Town of Milford Meeting Notice

Board or Commission: Conservation Commission

Date and Time of Meeting: Wednesday April 21, 2021 at 7.00 P. M

DECK PLAN 1/4

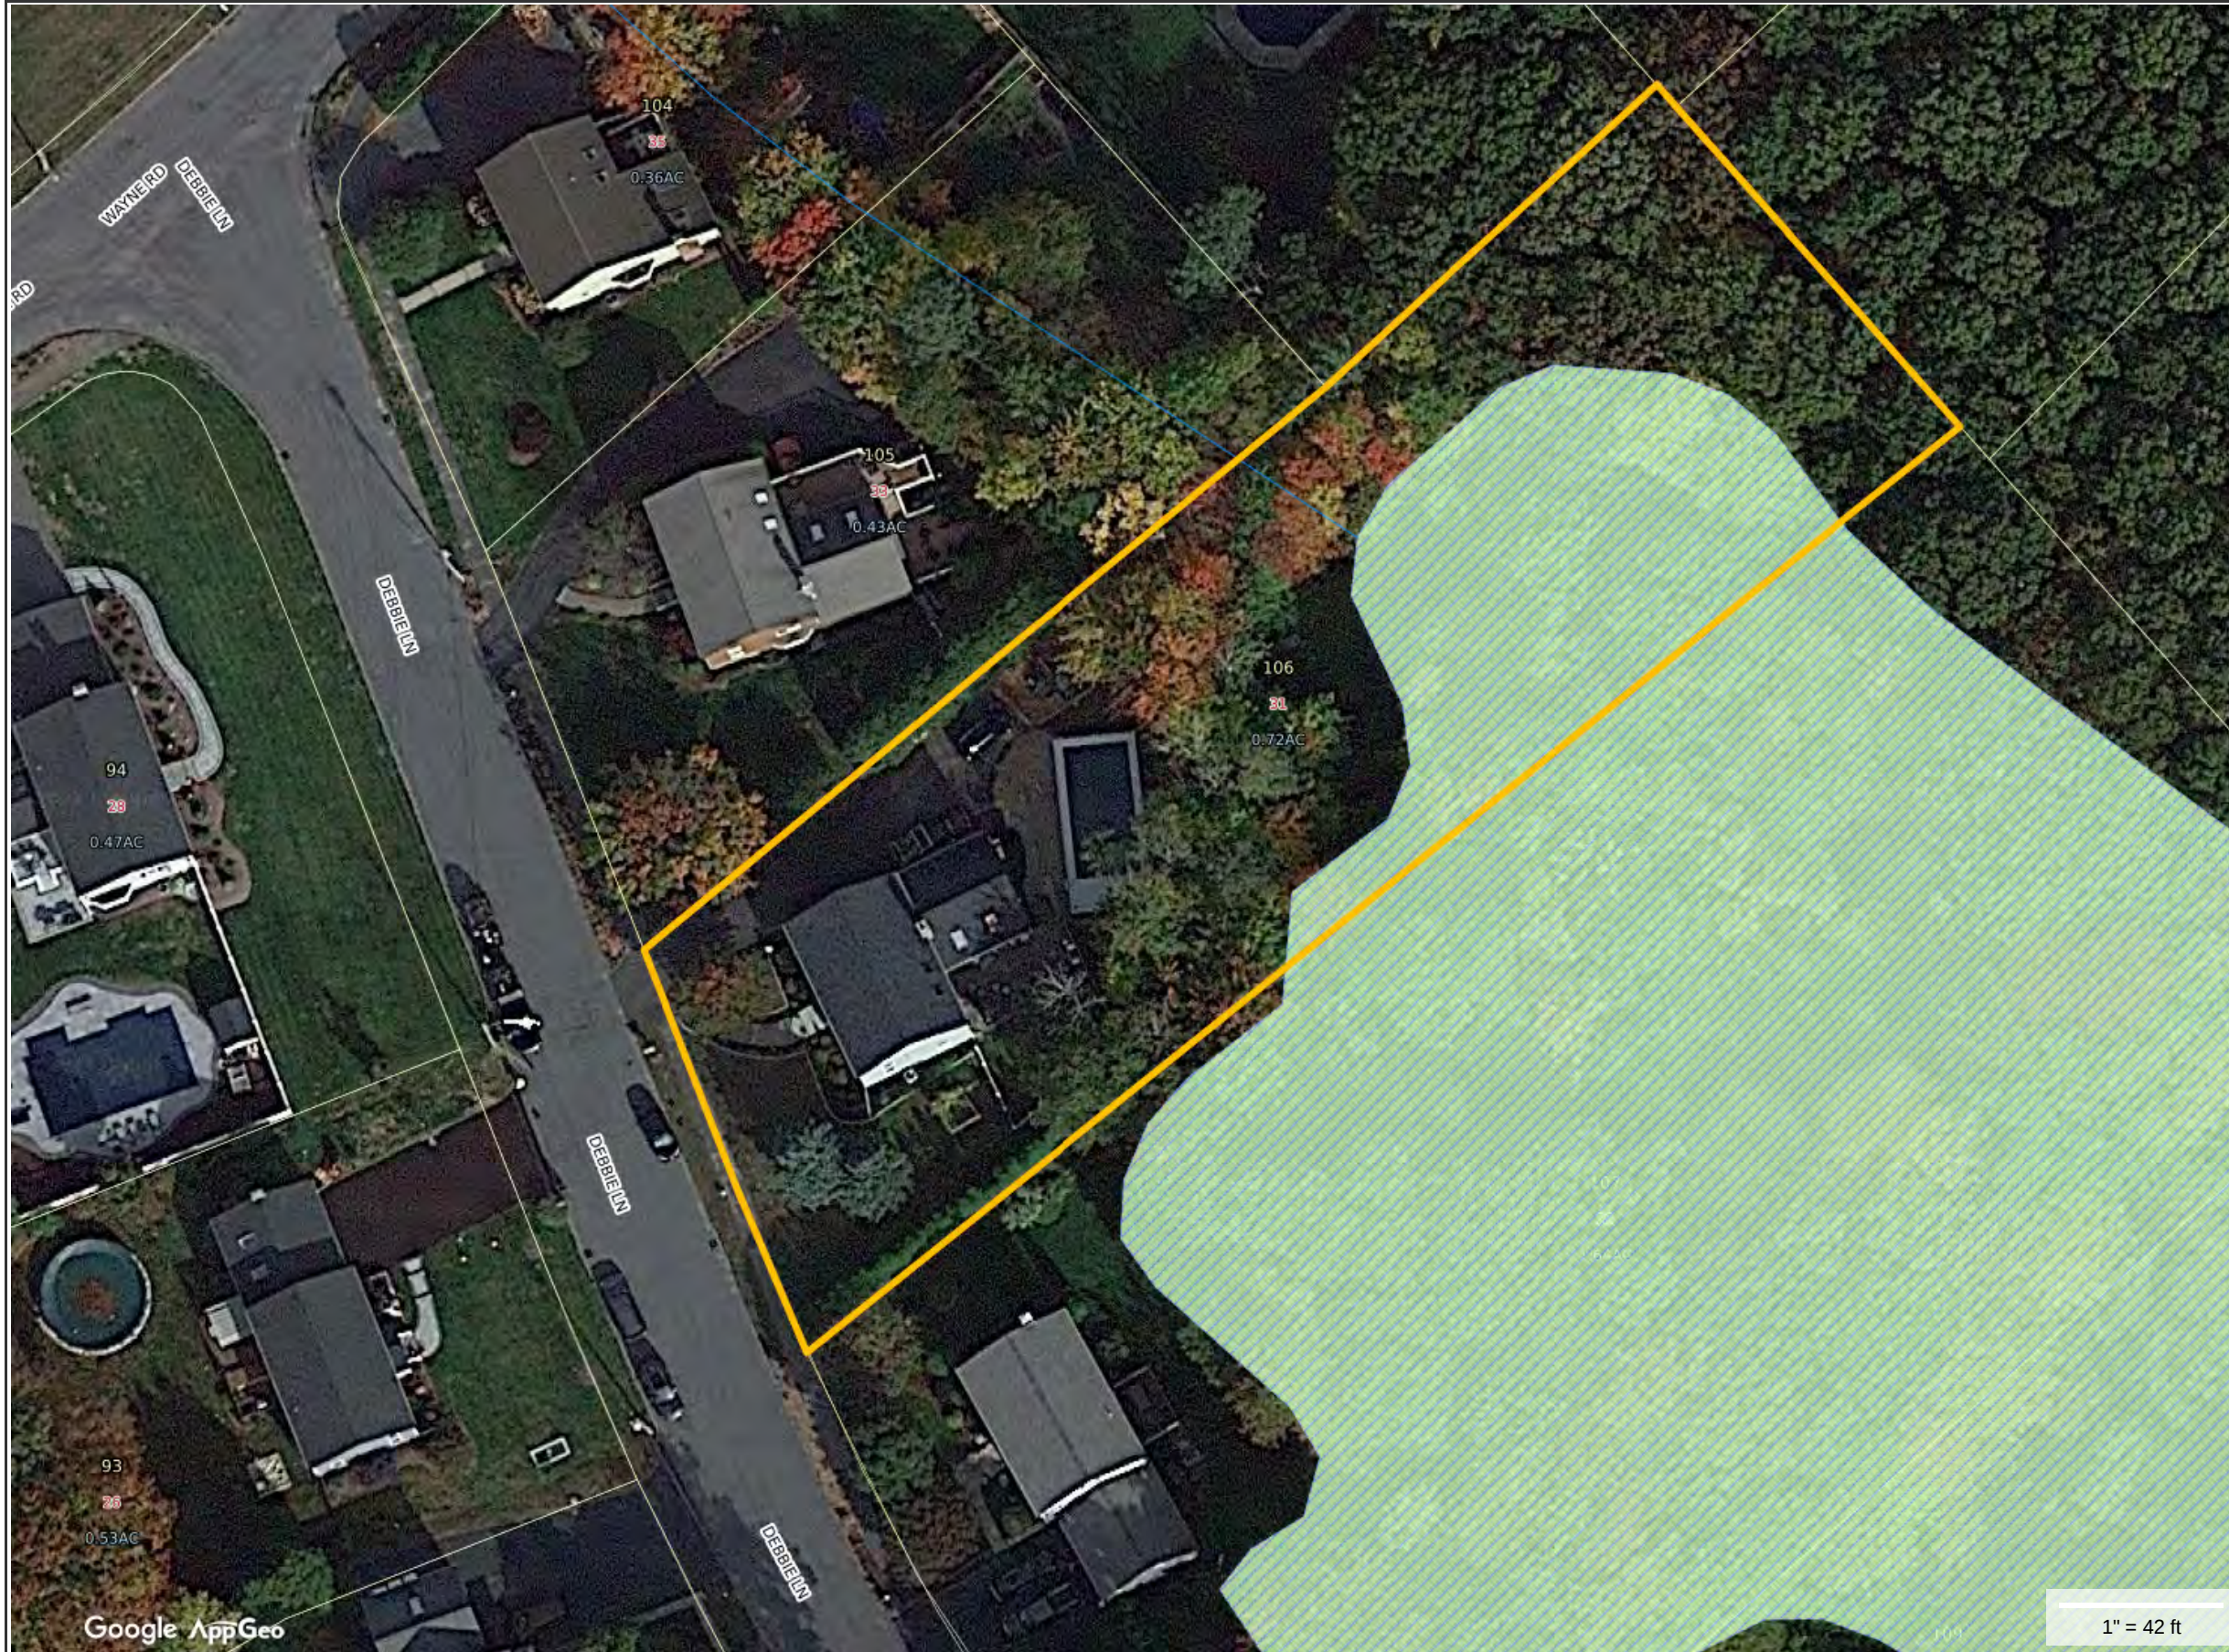
The submittal is a Notice of Intent associated with the installation of an above ground pool in the rear yard of an existing single-family house. The pool has already been installed, prior to any filing with the Conservation Commission.

1. The pool as installed is in close proximity to the Bordering Vegetated Wetlands (BVW). It is recommended the applicant have the BVW flagged and an engineered plan be submitted. The plan should accurately show the existing conditions, BVW, pool location, etc.
